Access Compliance Report

Public Rights-of-Way

(Curb Ramps)

Intersection ID: 12455	Main Street: W_3RD_ST	Cross Street: S_TRYON_ST	Location: W
ADA ID: A532A68F2586	Ramp Type: Perp	Initial Pass/Fail: Fail	Overall Compliance: No
Severity Score: 12.5			
Codes/Mitigation Info/Possible Solution		Field Measurements/Component Compliance

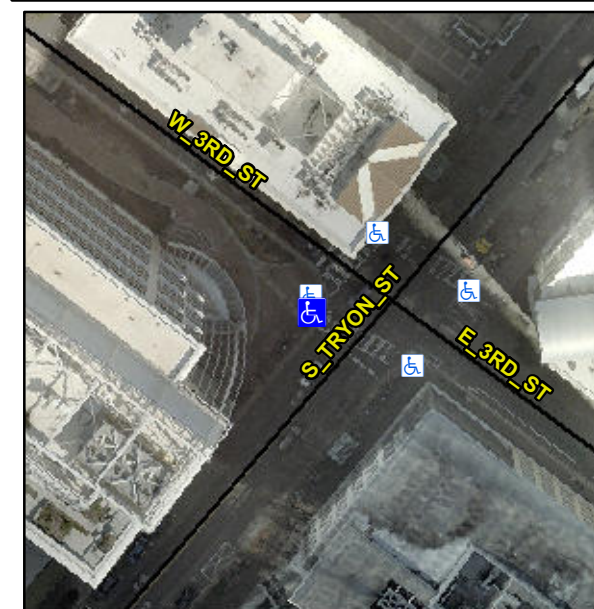
R304.5.3

Compliance	Description	Data	Compliance	Description	Data
N/A	Ramp Length (in)	24.0	Yes	Ramp Slope (%)	7.3
Yes	Ramp Width (in)	58.0	No	Ramp XSlope (%)	6.9
N/A	Flare Type LT	N/A	N/A	Flare Type RT	N/A
N/A	Flare Slope LT (%)	N/A	N/A	Flare Slope RT (%)	N/A
N/A	Flare Traversable LT?	N/A	N/A	Flare Traversable RT?	N/A
N/A	Landing Length (in)	N/A	N/A	DWS Provided?	N/A
N/A	Landing Width (in)	N/A	N/A	DWS Contrast?	N/A
N/A	Landing Slope (%)	N/A	N/A	DWS Length (in)	N/A
N/A	Landing X Slope (%)	N/A	N/A	DWS Full Width?	N/A
N/A	Landing Curb? (Y/N)	N/A	N/A	DWS Offset (in)	N/A
N/A	Shared Landing?	N/A			
N/A	Gutter Ponding?	N/A	N/A	Gutter Slope (%)	N/A
N/A	Gutter Lip Ht (in)	N/A	N/A	Gutter X Slope (%)	N/A
N/A	Painted X Walk1?	Yes	N/A	Painted X Walk2?	N/A
	X Walk 1 Direction	To SE		X Walk 2 Direction	N/A
N/A	X Walk 1 Width (in)	108.0	N/A	X Walk 2 Width (in)	N/A
	X Walk 1 Slope (%)	0.9		X Walk 2 Slope (%)	N/A
	X Walk 1 X Slope (%)	0.3		X Walk 2 X Slope (%)	N/A

Remove & Replace Entire Ramp.
